**CLARKE COUNTY PLANNING COMMISSION
TABLE OF CONTENTS
November 2, 2018 Business Meeting**

SITE PLAN AMENDMENT (SP-18-02)

Re: Handy Mart Diesel Pump Expansion - Site Development Plan
Site Plan and Erosion and Sediment Control Plan Review (1st Submittal)
H&P JN 20181366
Comment Response Letter

Re: Handy Mart Truck Fueling Station Addition
First review comments response

SHEET 12 OF 13

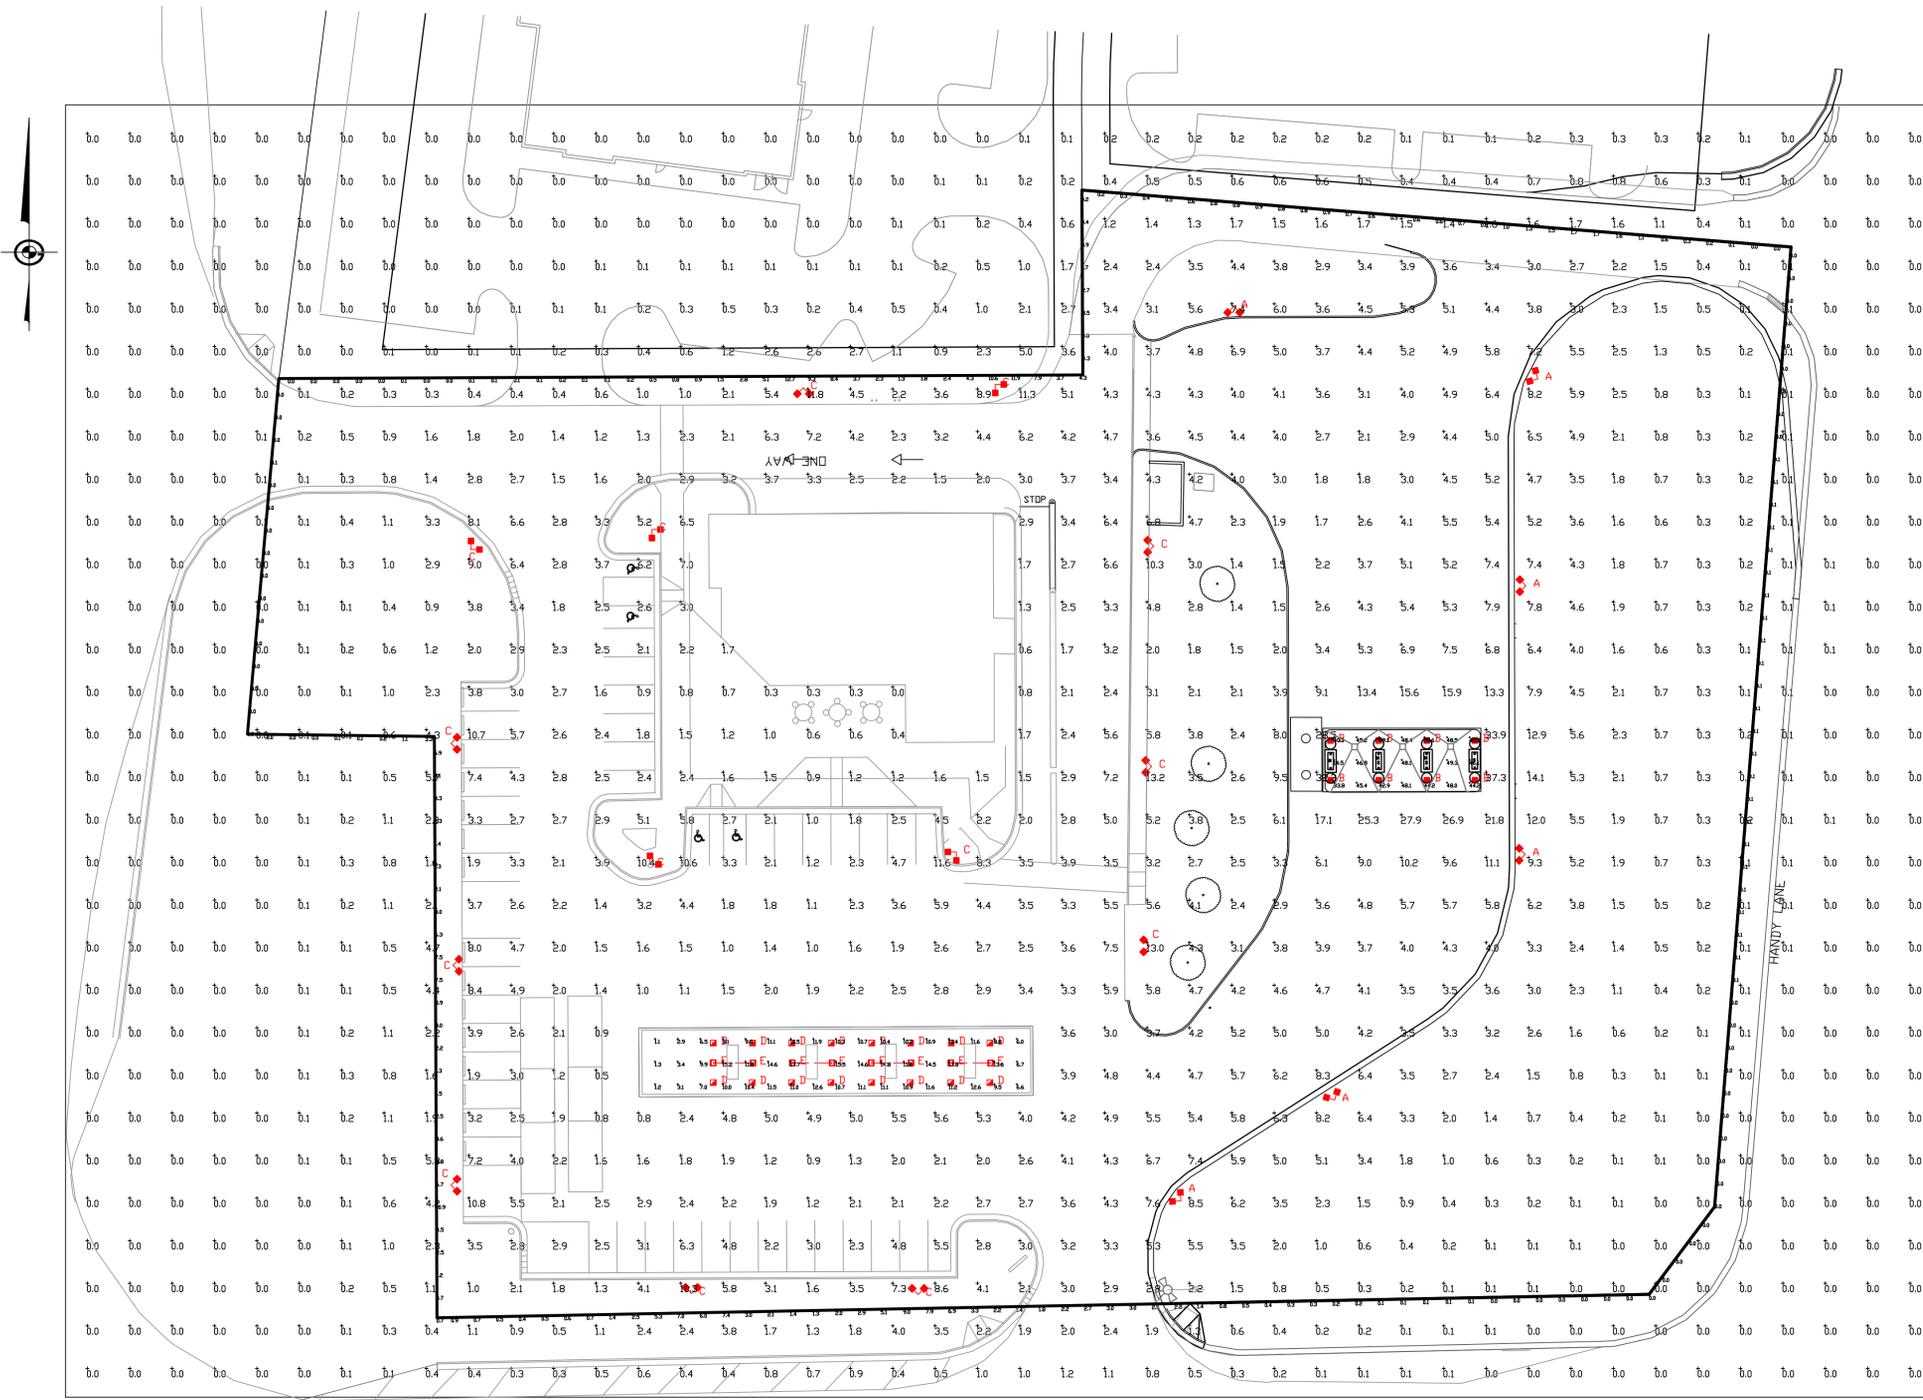
Comment 39: *Landscape Plan not as same scale as site plan as required by paragraph 6-G-23 of County Code.*

Response: The landscape plan has been revised to match the scale (1"=25') of the site plan, see sheet 12.
